March 25, 2014

**Subject: Response to DEQ Comments
Proposed Surface Soil Sampling – DU-6
Willamette Cove Upland Facility**

Proposed DU-6 Surface Soil Sampling
Willamette Cove Upland Facility
Portland, Oregon

Figure 3

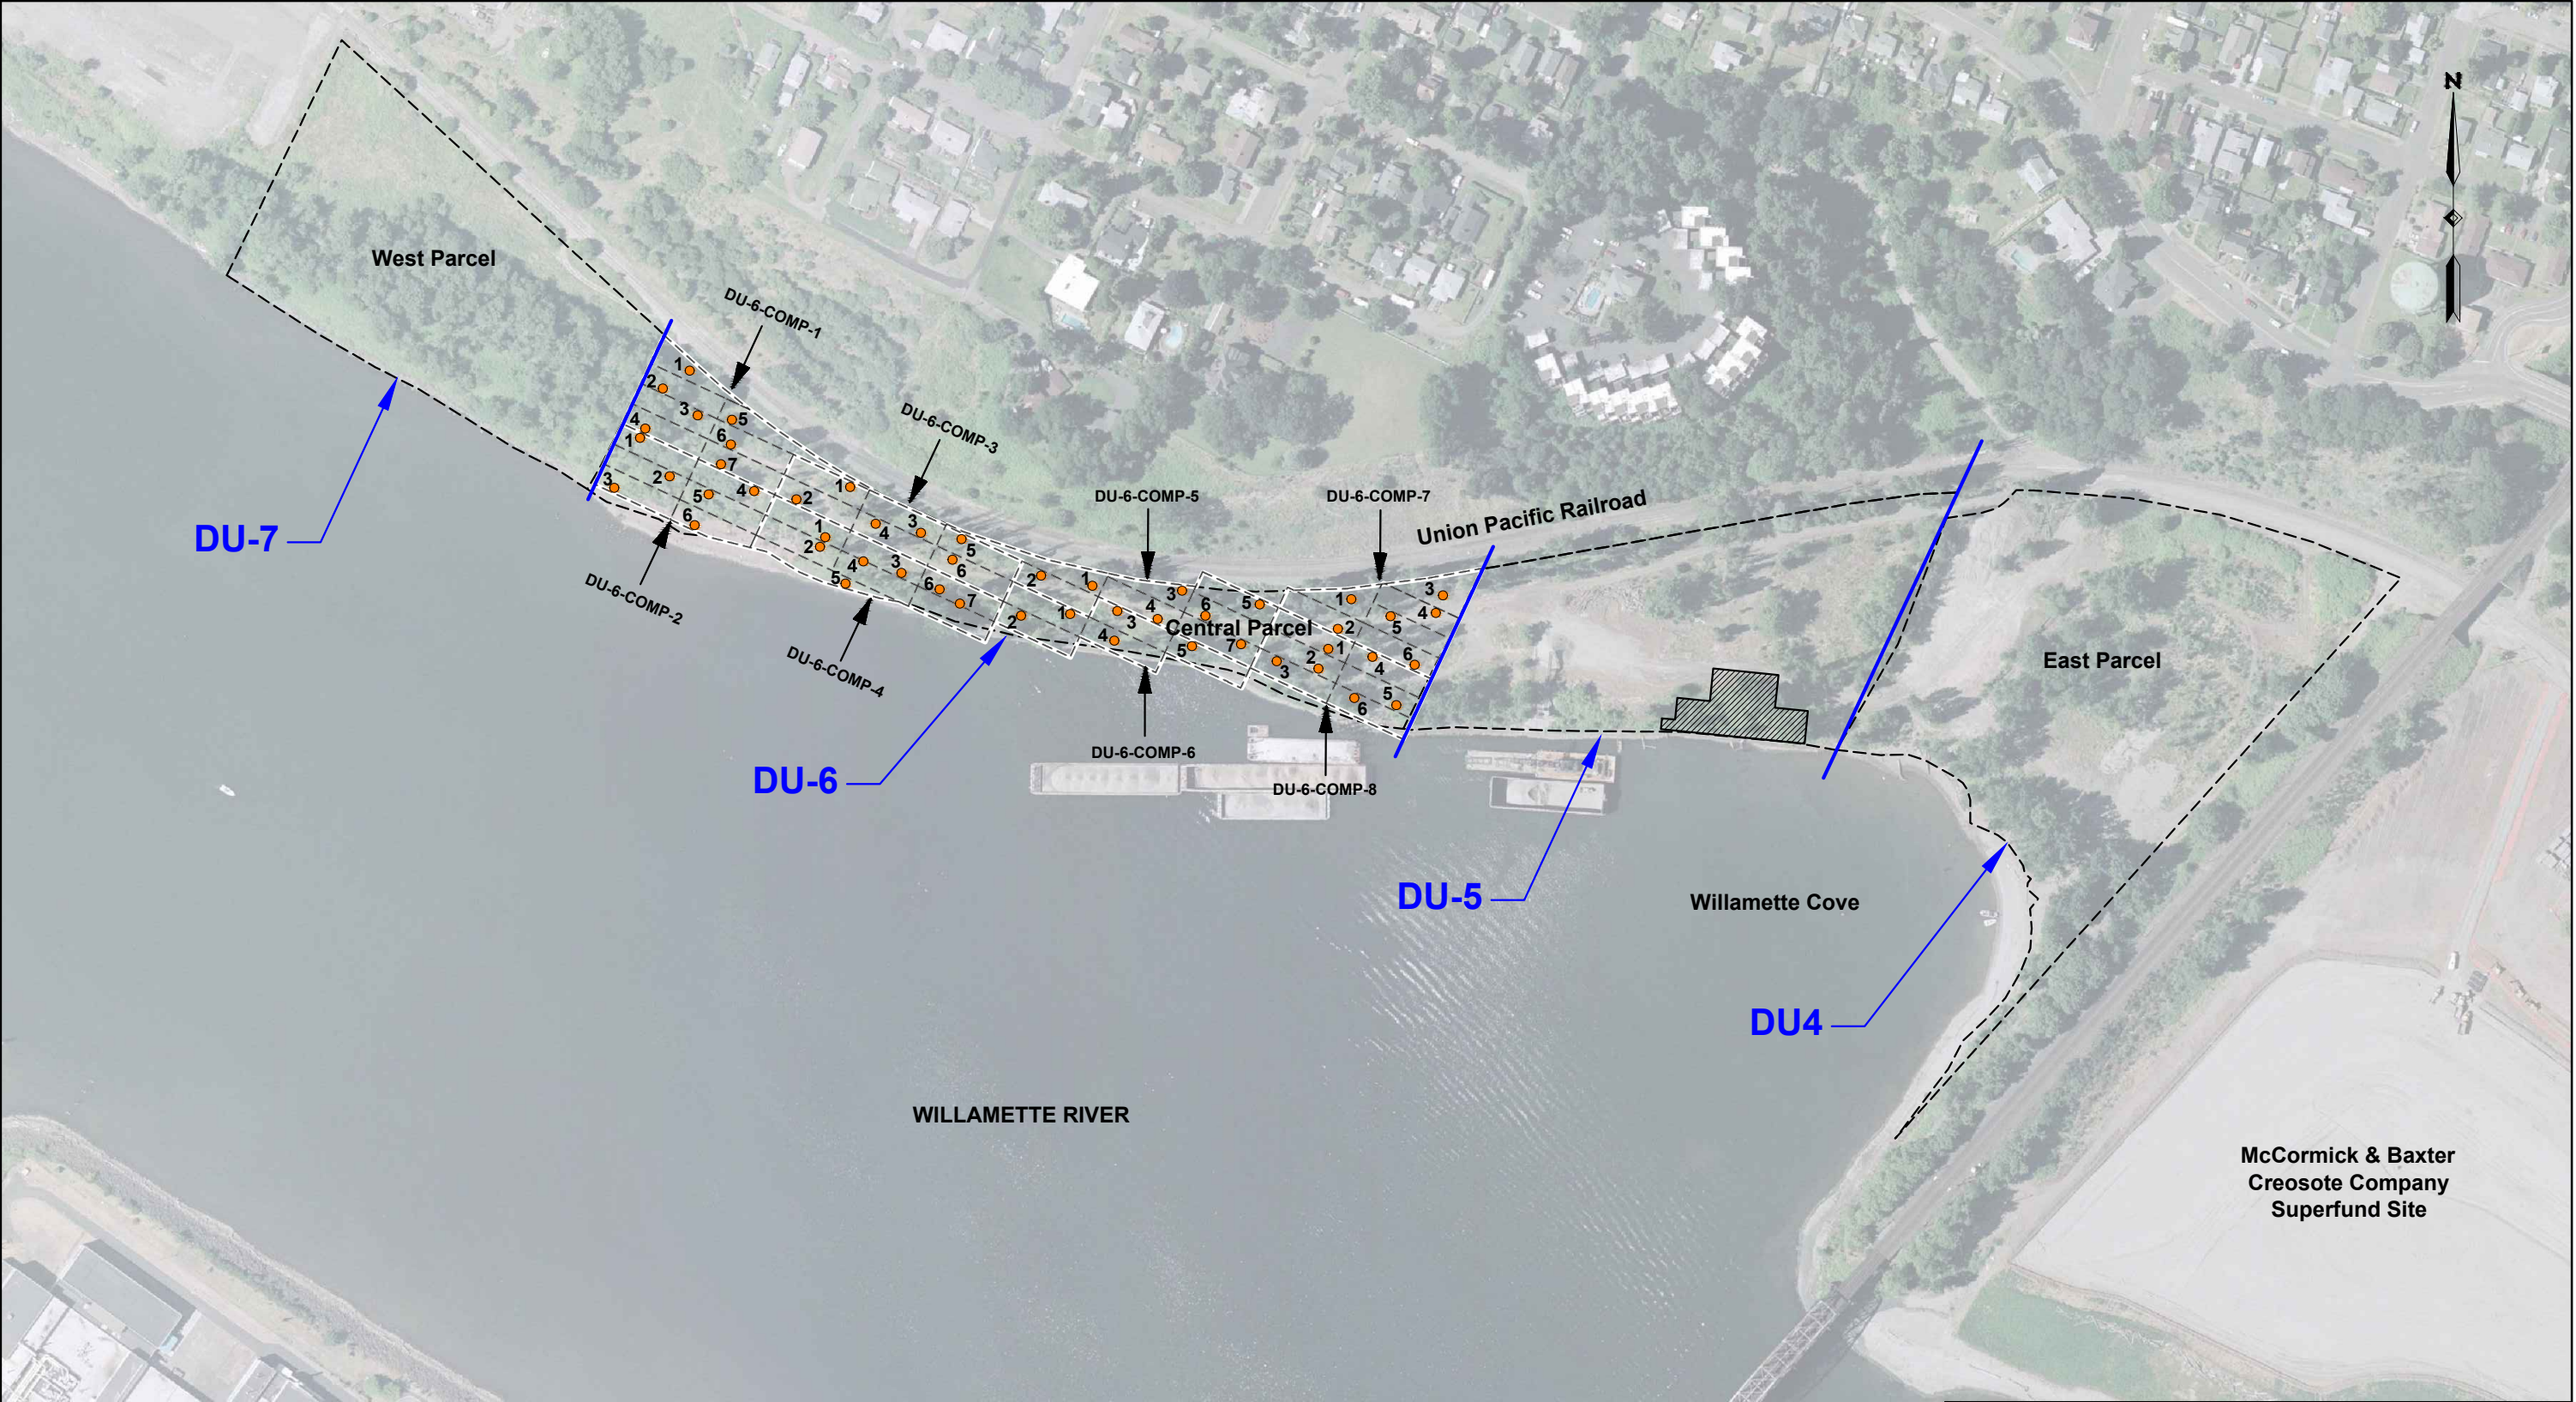
- Case 4: Other. A similar process would be used for any other result from the first round of composite sampling.
- 5) *Composite Sample Units. Since the distribution of contamination is not known, and given concerns about upland soil being a source of contamination to the riverbank and river, we recommend breaking each unit into two (one riverward and one upland subunit). This would provide more information on the distribution and has the advantage of smaller composites which is preferred when incremental sampling is not performed.*

- 6) Composite Size. *Composite are is made up of 12-13 sampling locations. The sampling number should be the same between each unit. In general, we believe the soil volumes and decision unit sizes are too big for composites without using ISM methods, and thus recommend splitting the proposed decision units as described above.*

Response. The Port agrees with this approach. The attached figure presents the revised sample composites. The initial analyses include the eight composites (rather than four) with four riverward and four upland.

Response. As discussed in response to Comment #1, to maintain consistency with the prior sampling, the subsamples to be used for compositing will be collected from the same 50 locations as the incremental samples collected during the ISM samples. Given that constraint, we selected the composite subsample number to be as equal as practicable. As noted above in the response to Comment #5, the Port revised (split) the composite sample areas per the DEQ's recommendation.
